APPLICATION FOR PERMIT
TYPE I MUNICIPAL SOLID WASTE FACILITY
MSW PERMIT NO. 2374
PESCADITO ENVIRONMENTAL
RESOURCE CENTER
RANCHO VIEJO WASTE MANAGEMENT, LLC
SOLID WASTE DISPOSAL FACILITY
LAREDO, WEBB COUNTY, TEXAS

September 15, 2011

**Reference: Pescadito Environmental Resource Center – Webb County
Municipal Solid Waste (MSW) – Proposed Permit No. 2374
Response to First Notice of Deficiency (NOD)
Tracking No. 14710139; CN603835489/RN106119639**

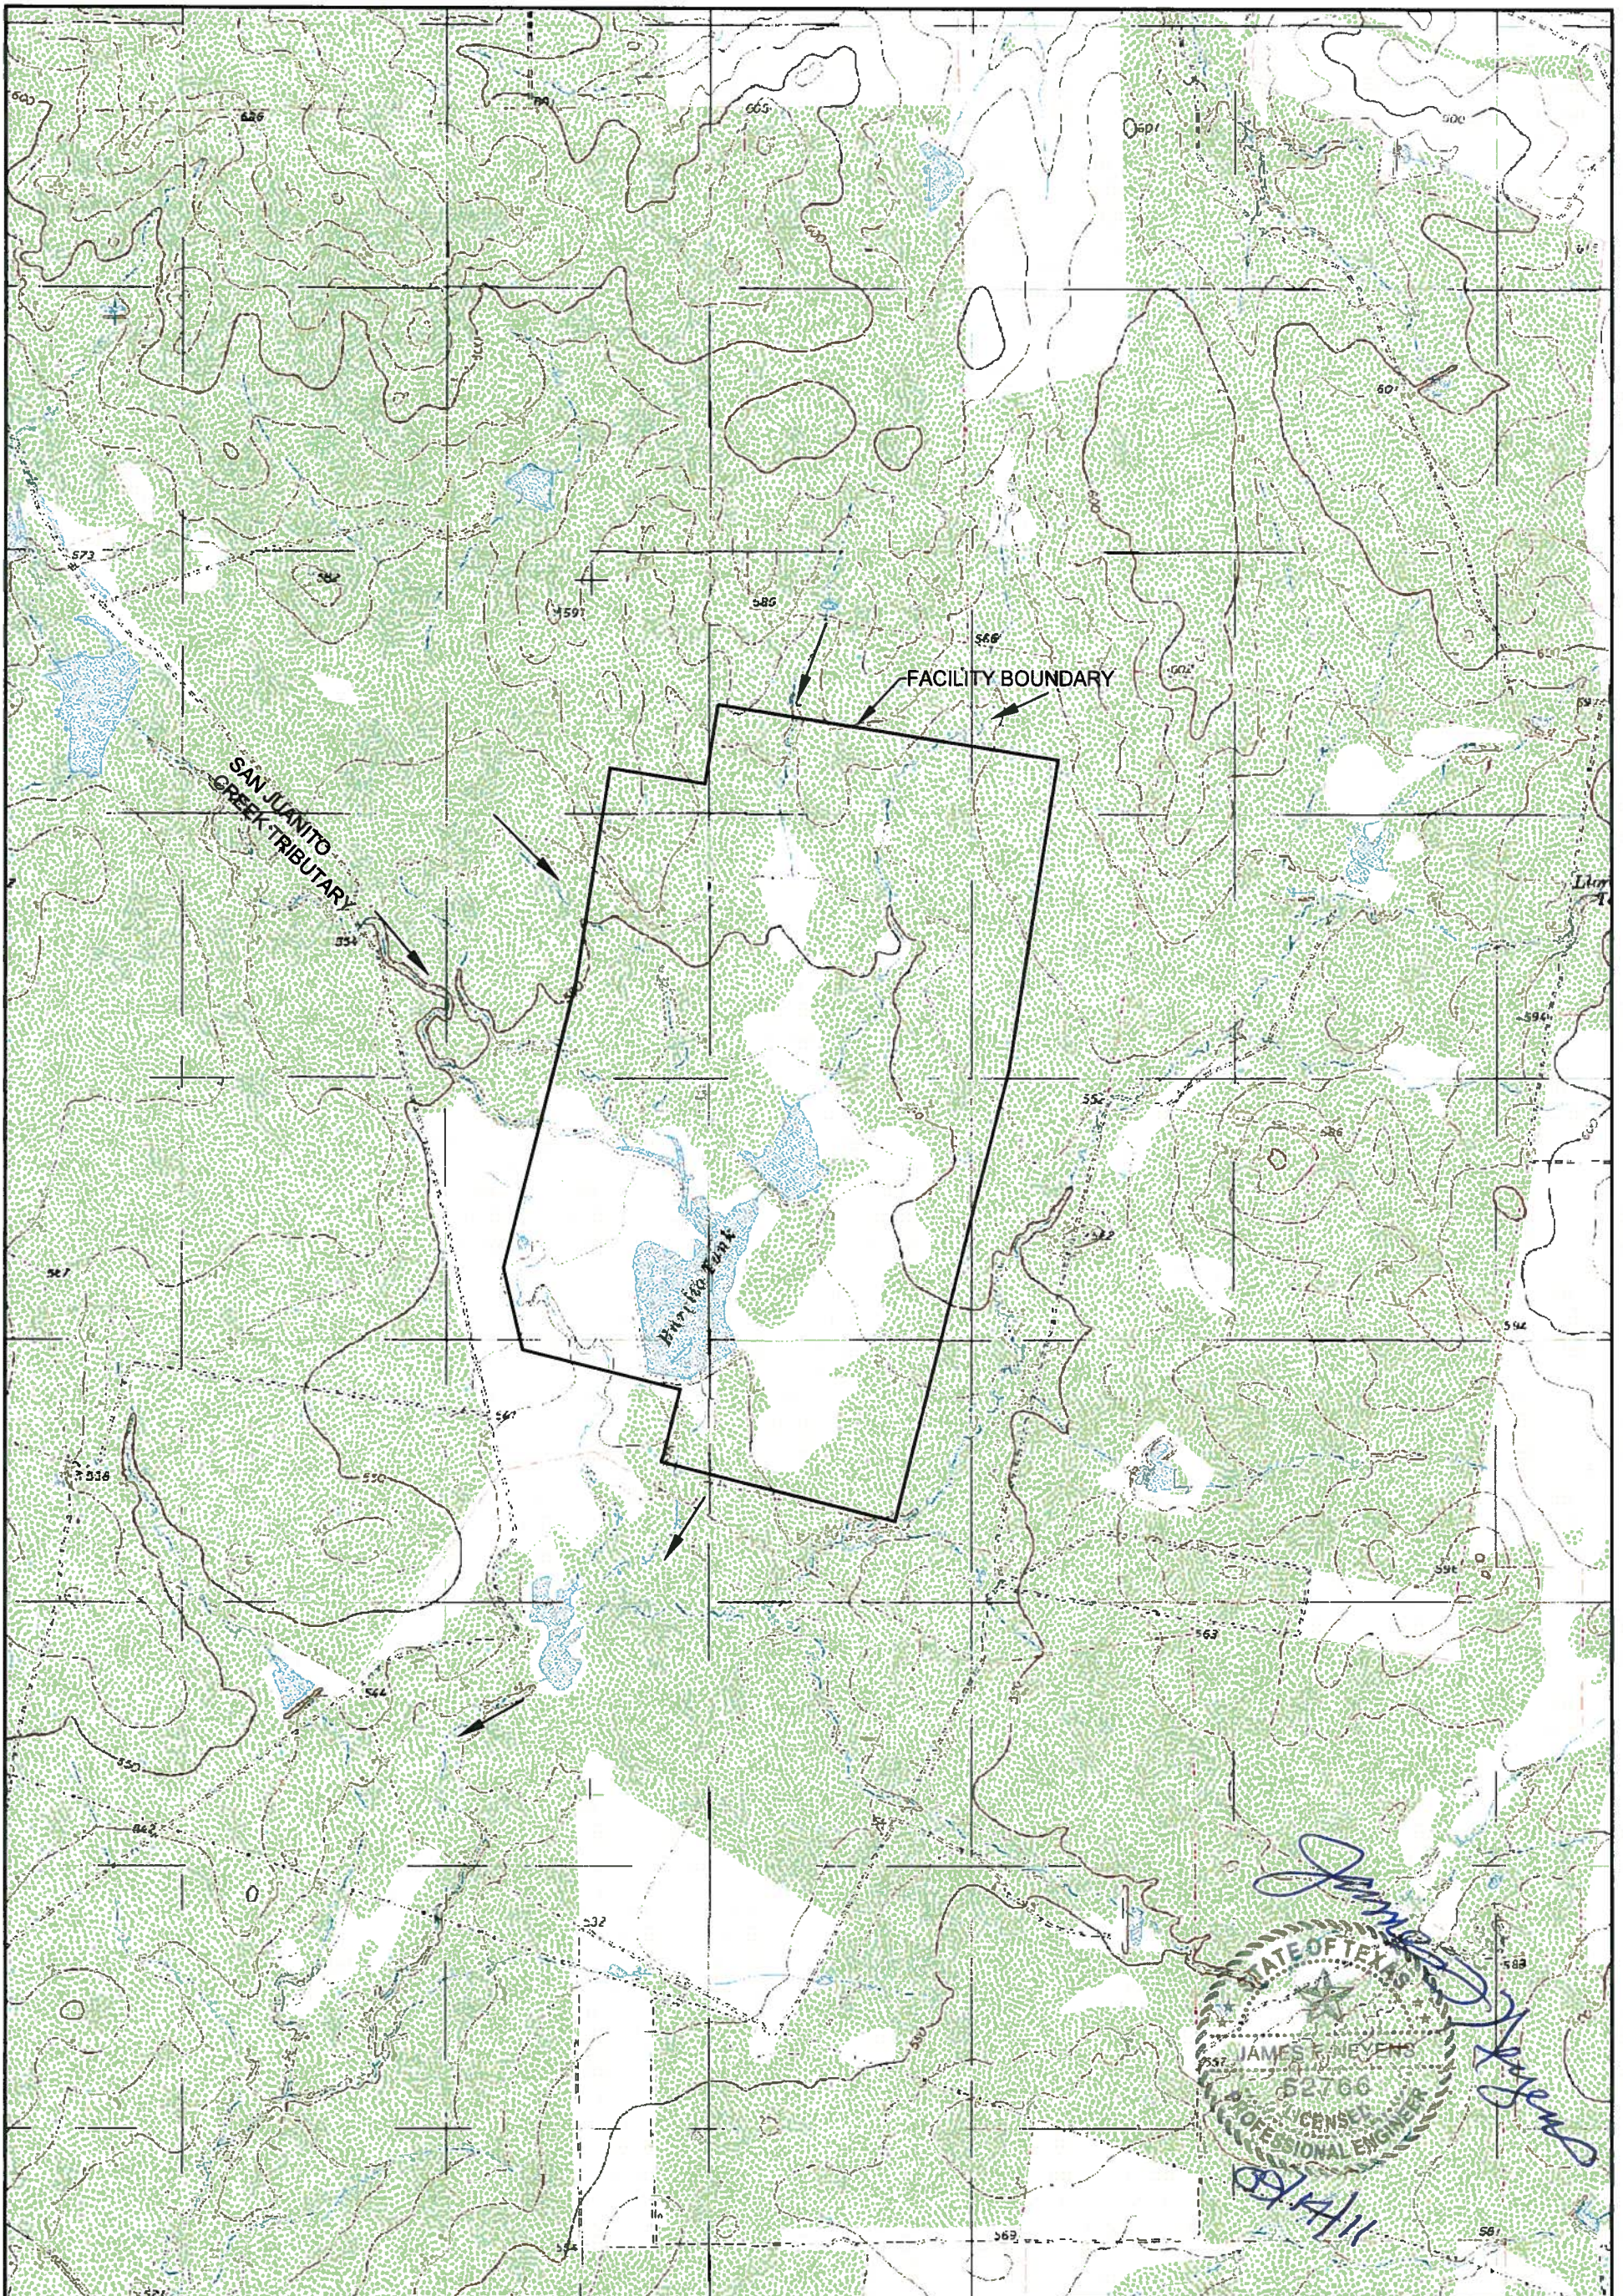
a.) *Please identify the name of the watercourse associated with the proposed project and the flow direction. (30 TAC §301.33(a)(2)).* We have provided the name of the main watercourse associated with the proposed project and the flow direction on Figure 6, Part II.

REV. 1 8/24/11	ADDED ONE STRUCTURE	
LAND USE MAP		
PESCADITO ENVIRONMENTAL RESOURCE CENTER MSW PERMIT NO. 2374 WEBB COUNTY, TEXAS		
PROJECT NO.	170401	DWG FILE 170401-MSW-II-8
DRAWN BY.	CL	DATE 02/14/11
		505 EAST HUNTLAND DRIVE SUITE 250 AUSTIN, TEXAS 78752 (512) 329-6080
		FIGURE 8 PART II PAGE XX

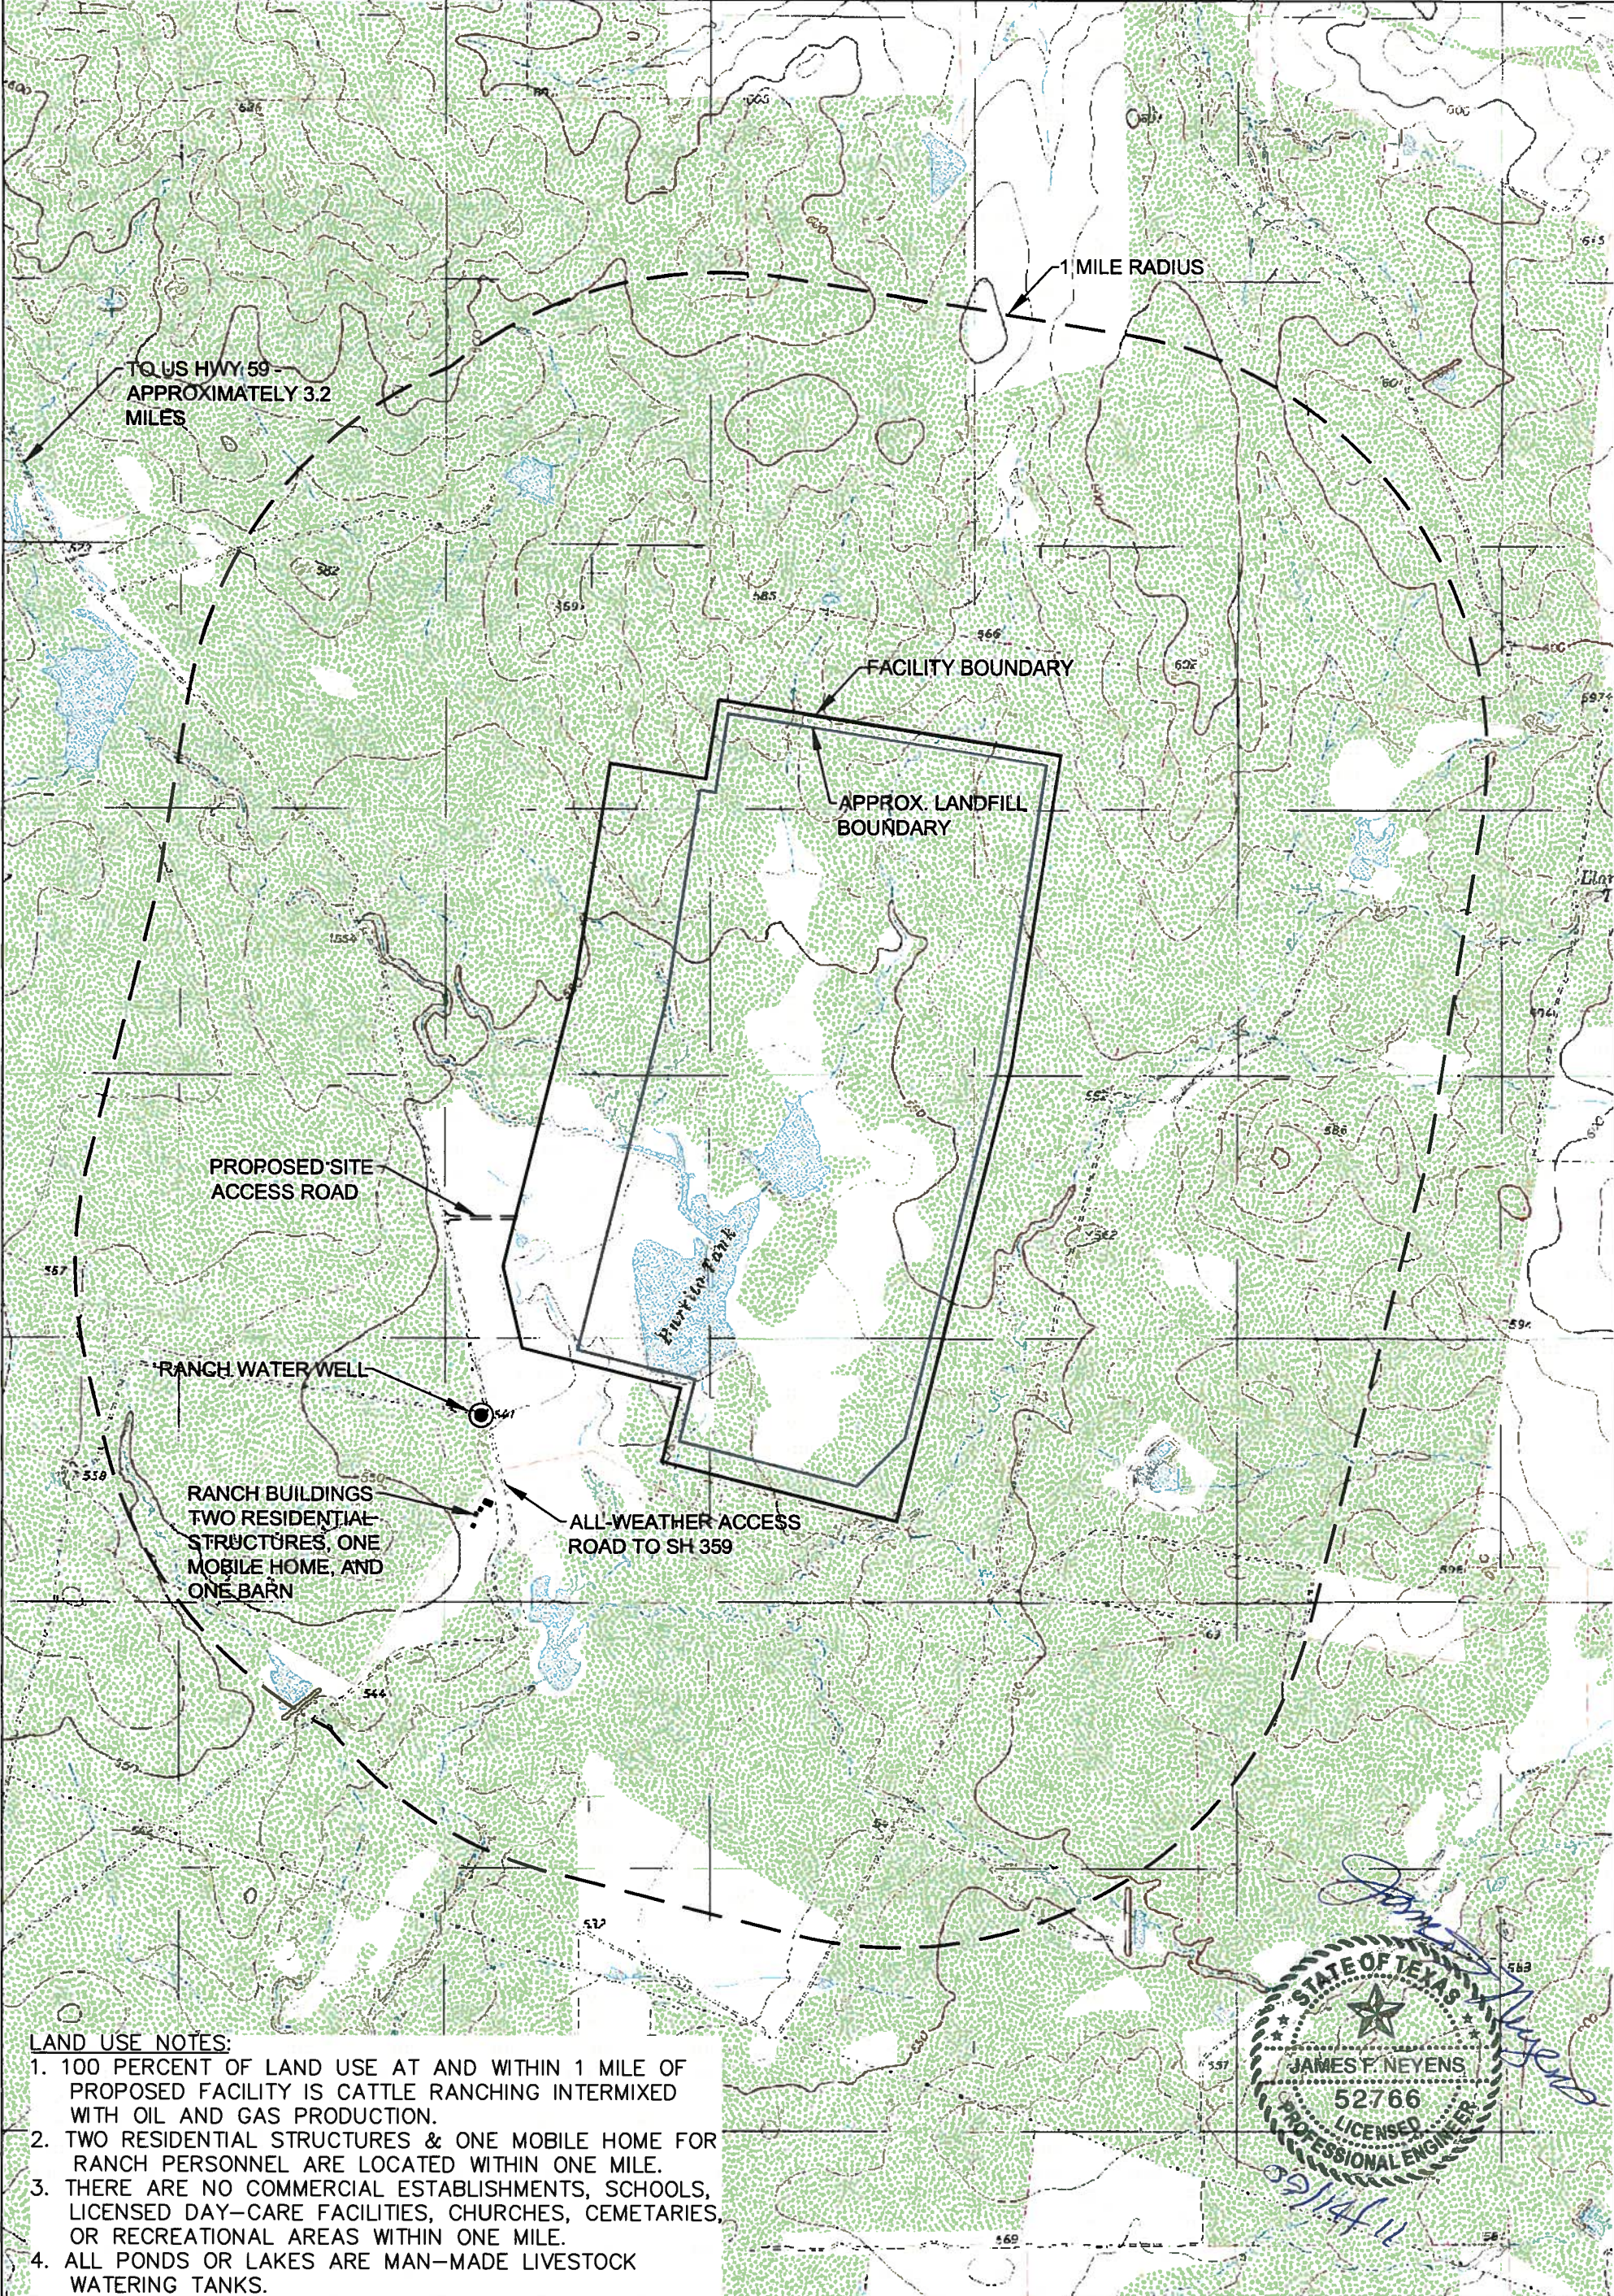
45. *Land-Use Map, Section 7.0. Note 5 of Figure 8 Land Use Map, states that easements are shown on Part II, Figure 9. Please note, the easements that may be discerned from Figure 9 do not appear to include all those identified on the Boundary Survey found in the Figures section of Part I. Please address this discrepancy. (30 TAC §330.61(g)).*

We have revised Note 5 on Figure 8. Easements are shown on Figure 4, Sheets 1 of 2 and 2 of 2 in Part I.

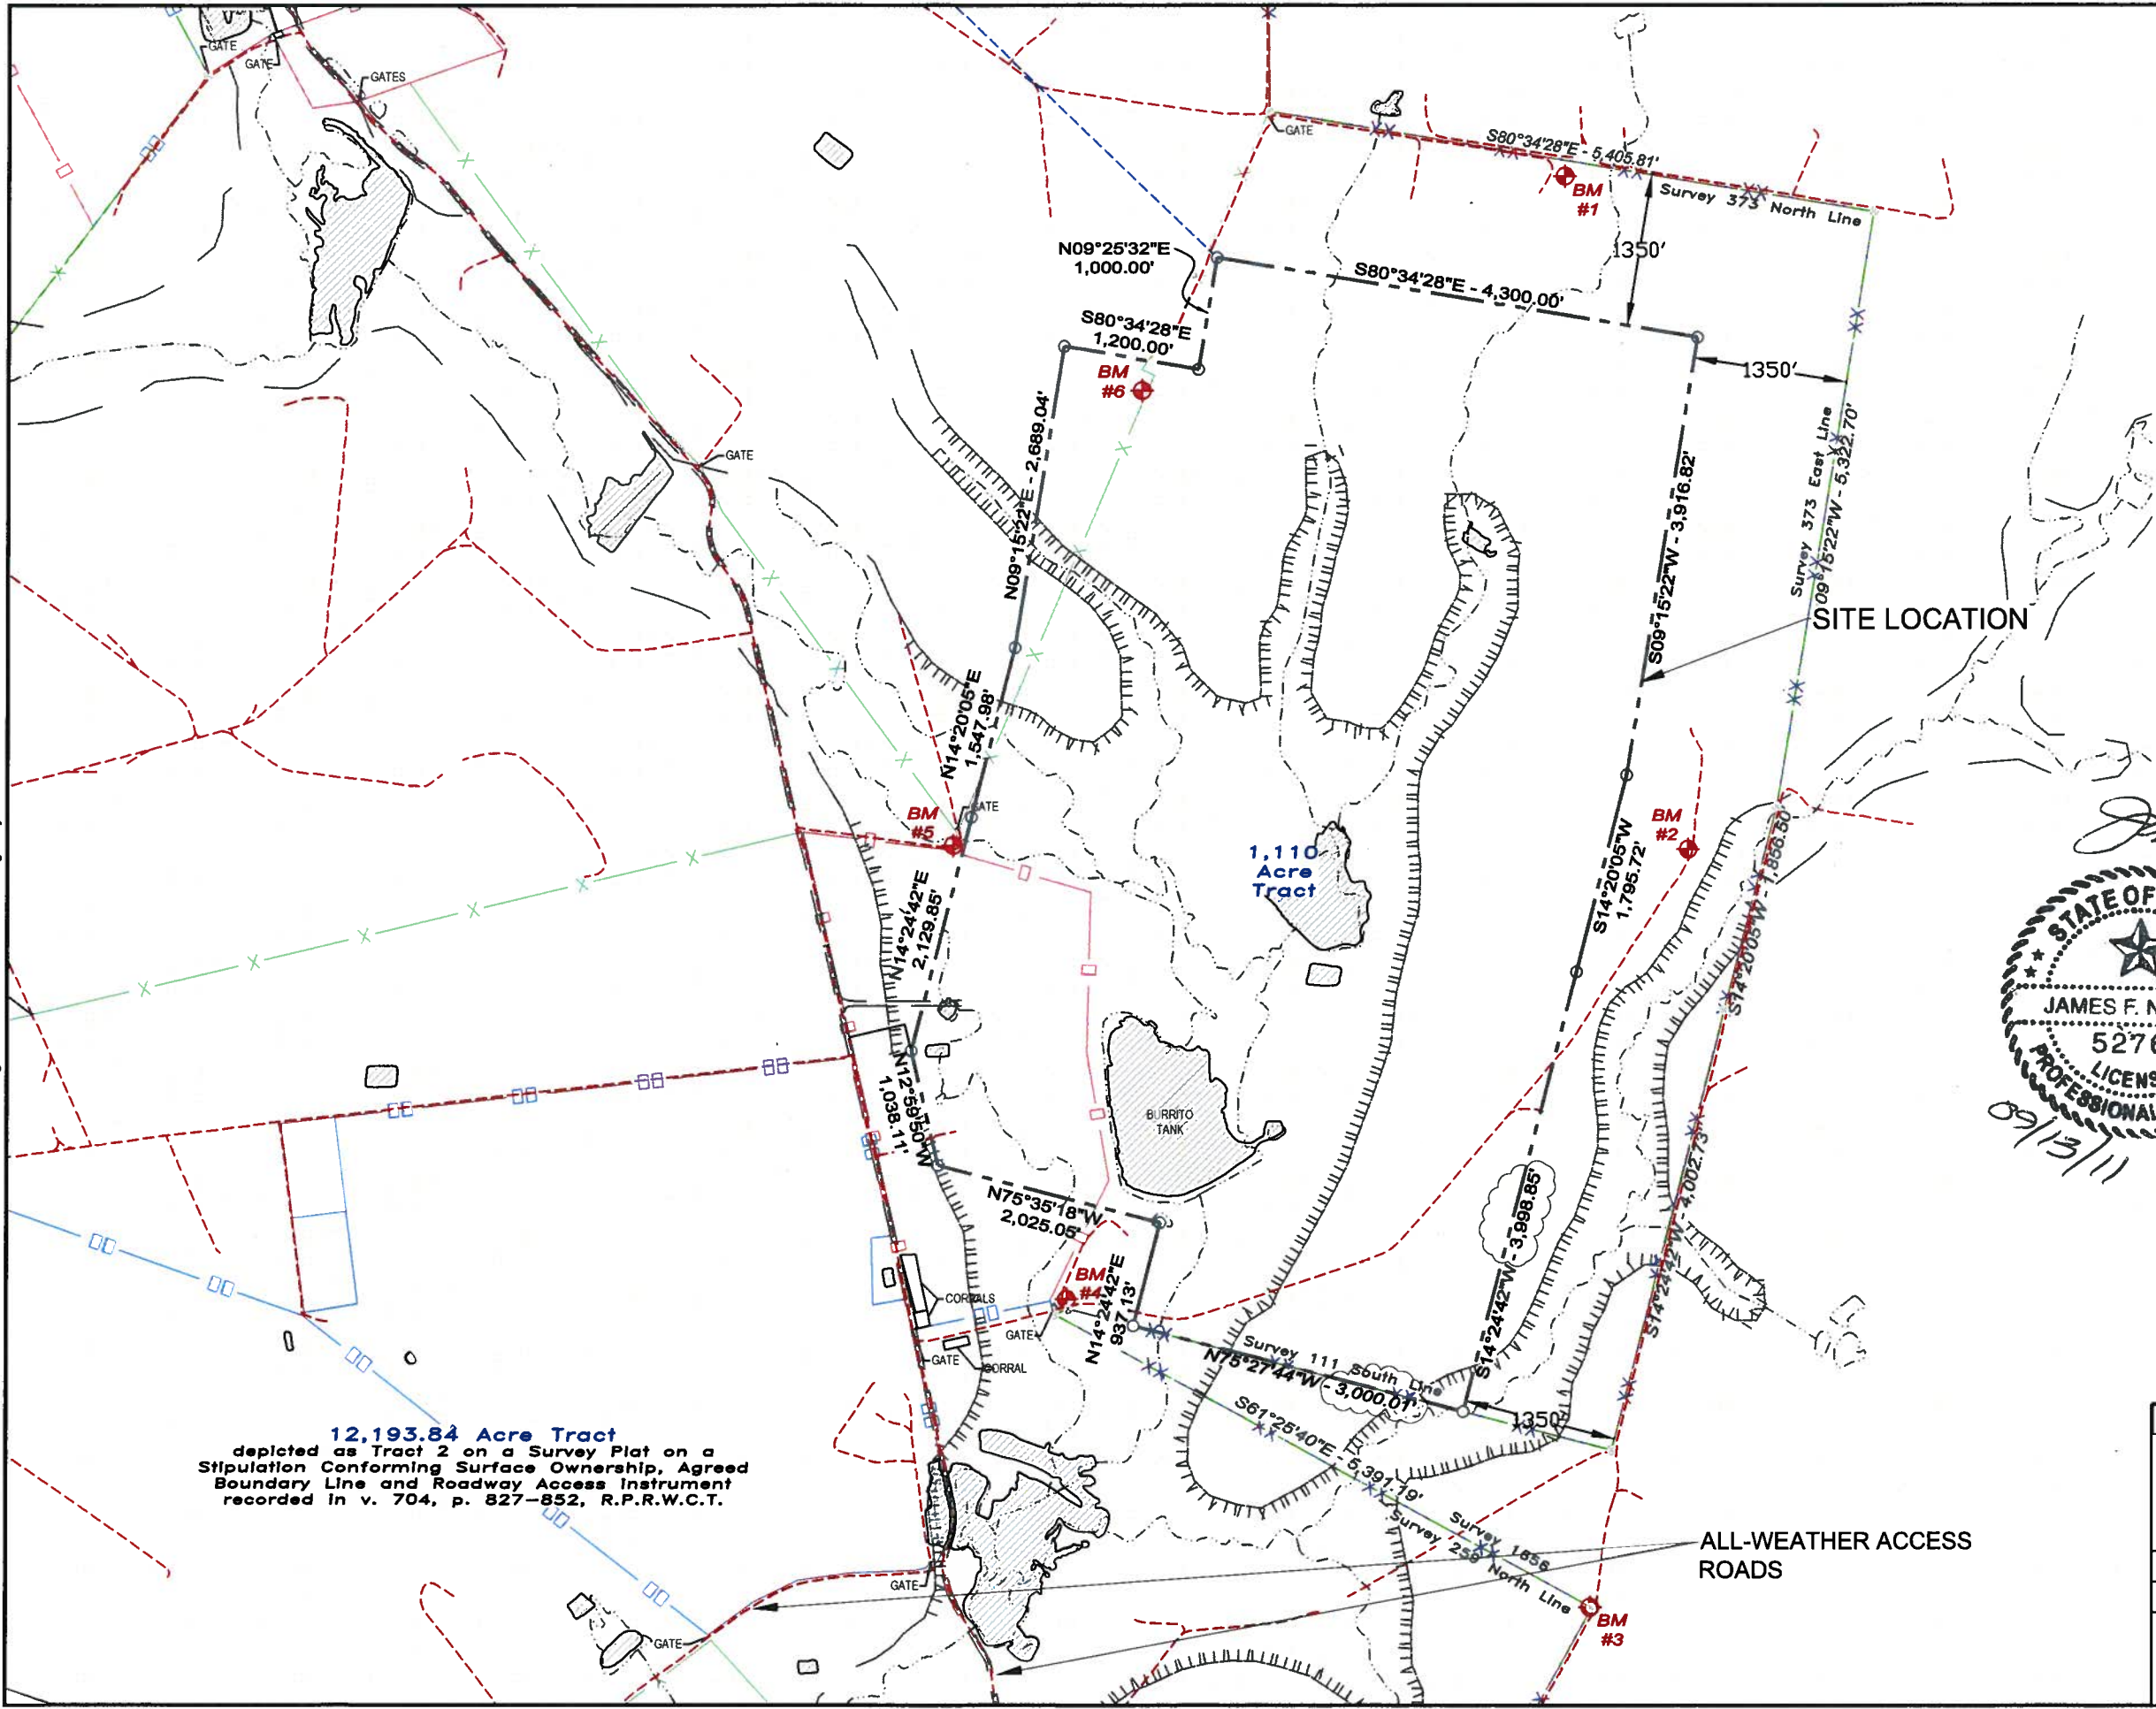
Figure 10. However, the text in Section 13.0 identifies the drawing as Figure 9. Please correct this discrepancy. (30 TAC §330.61(m)(1)).

We have corrected the figure identification to be Figure 11 in both Section 13.0 and in the Table of Contents.
